APPLICATION FOR PERMIT TO DRILL OR REENTER

8. Lease Name and Well No.
RED HILLS UNIT
130H (323150)

PECOS DISTRICT
DRILLING CONDITIONS OF APPROVAL

PECOS DISTRICT
SURFACE USE
CONDITIONS OF APPROVAL

Multi-bowl Wellhead Diagram
Red Hills Unit 130H
Cimarex Energy Co.
32-25S-33E
Lea Co., NM

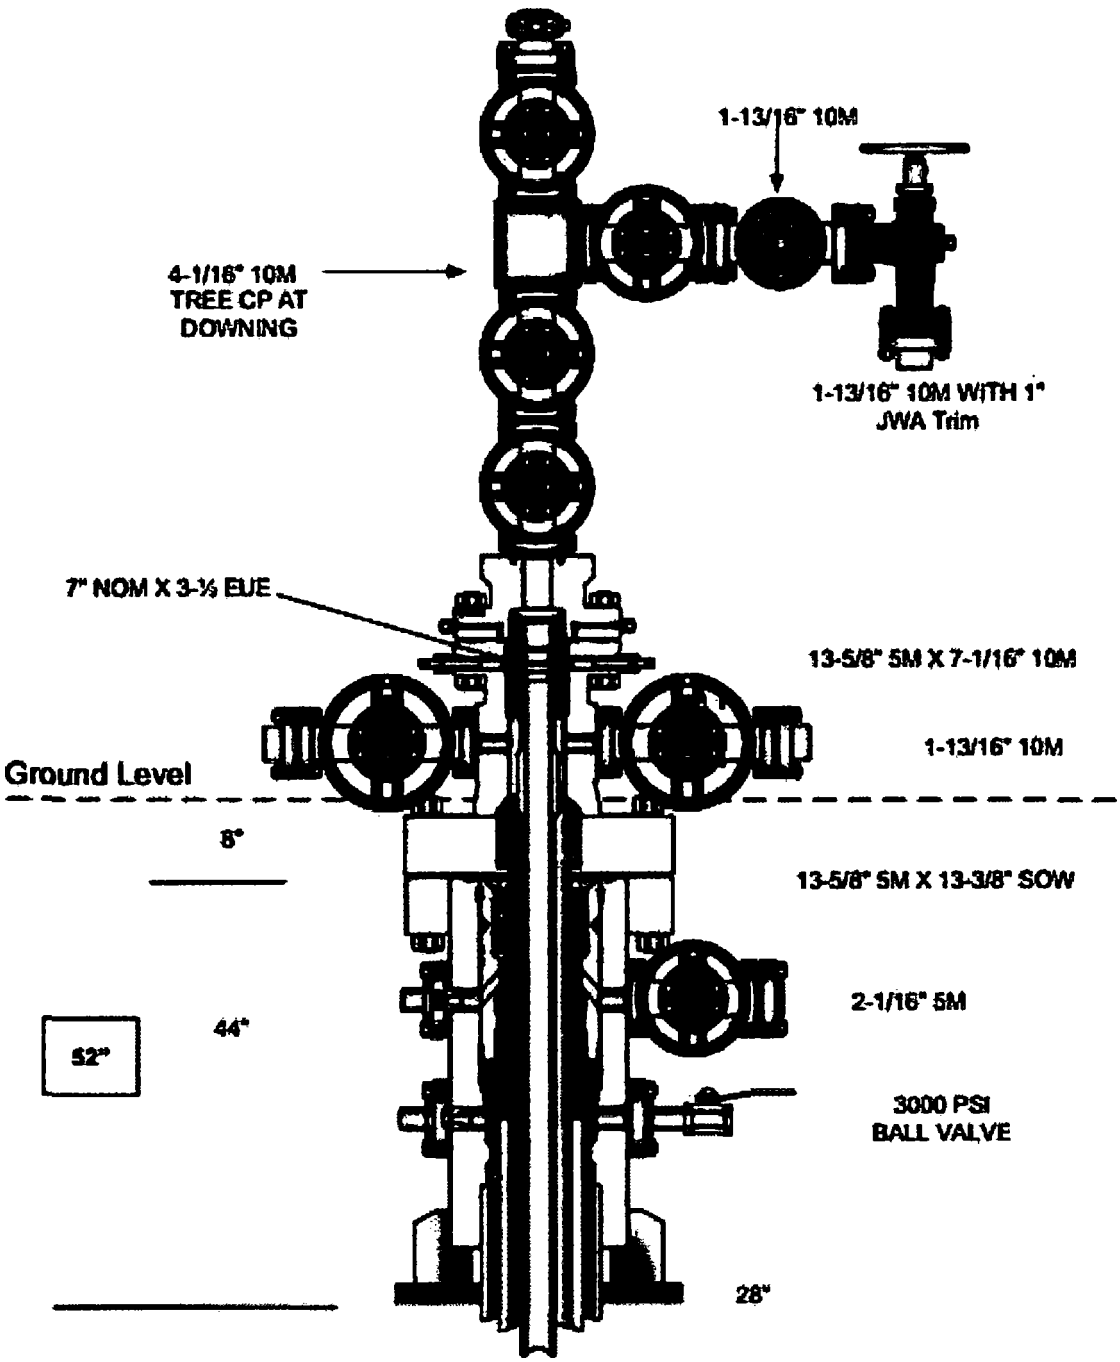
3. Operator has proposed a multi-bowl wellhead assembly. This assembly will only be tested when installed on the surface casing. Minimum working pressure of the blowout preventer (BOP) and related equipment (BOPE) required for drilling below the surface casing shoe shall be **3000 (3M)** psi.

a. Wellhead shall be installed by manufacturer's representatives, submit documentation with subsequent sundry.
   b. If the welding is performed by a third party, the manufacturer's representative shall monitor the temperature to verify that it does not exceed the maximum temperature of the seal.

c. Manufacturer representative shall install the test plug for the initial BOP test.
   d. If the cement does not circulate and one inch operations would have been possible with a standard wellhead, the well head shall be cut off, cementing operations performed and another wellhead installed.

e. Whenever any seal subject to test pressure is broken, all the tests in OOGO2.III.A.2.i must be followed.

Co-Flex Hose Hydrostatic Test
Red Hills Unit 130H
Cimarex Energy Co.
32-25S-33E
Lea Co., NM

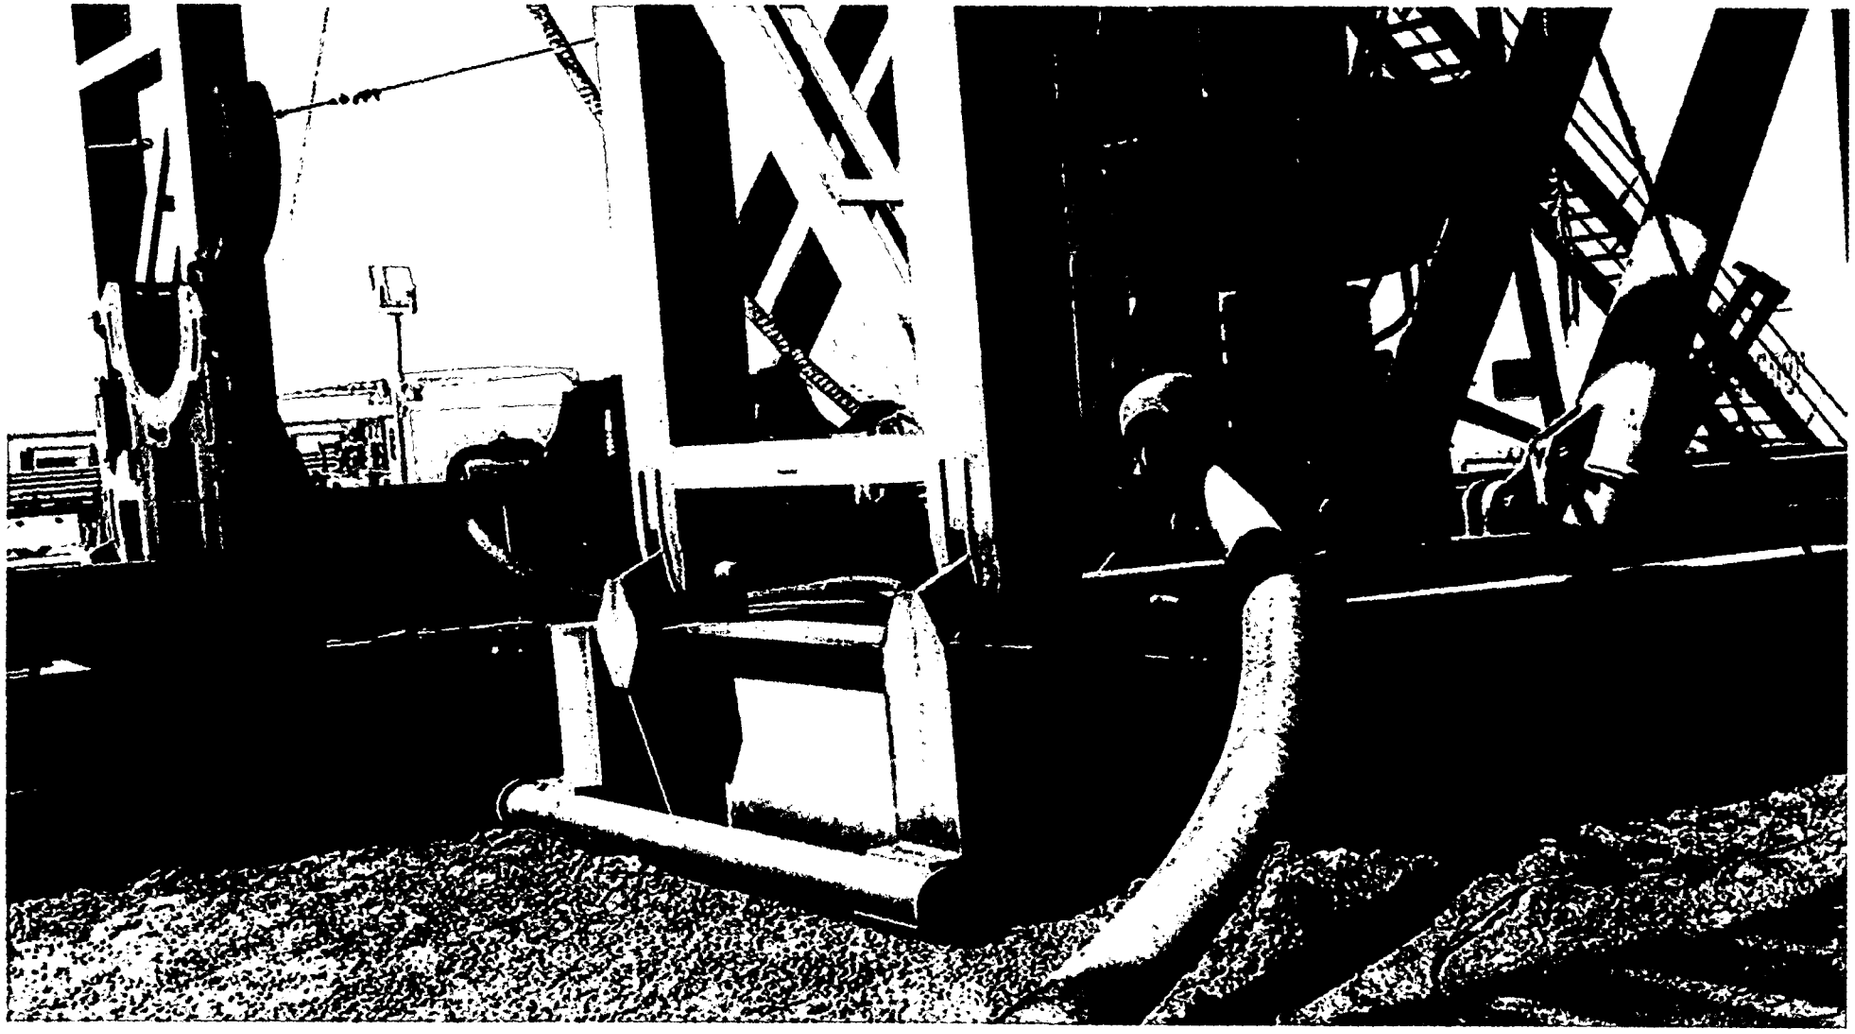
1. Variance approved to use flex line from BOP to choke manifold. Manufacturer's specification to be readily available. No external damage to flex line. Flex line to be installed as straight as possible (no hard bends).
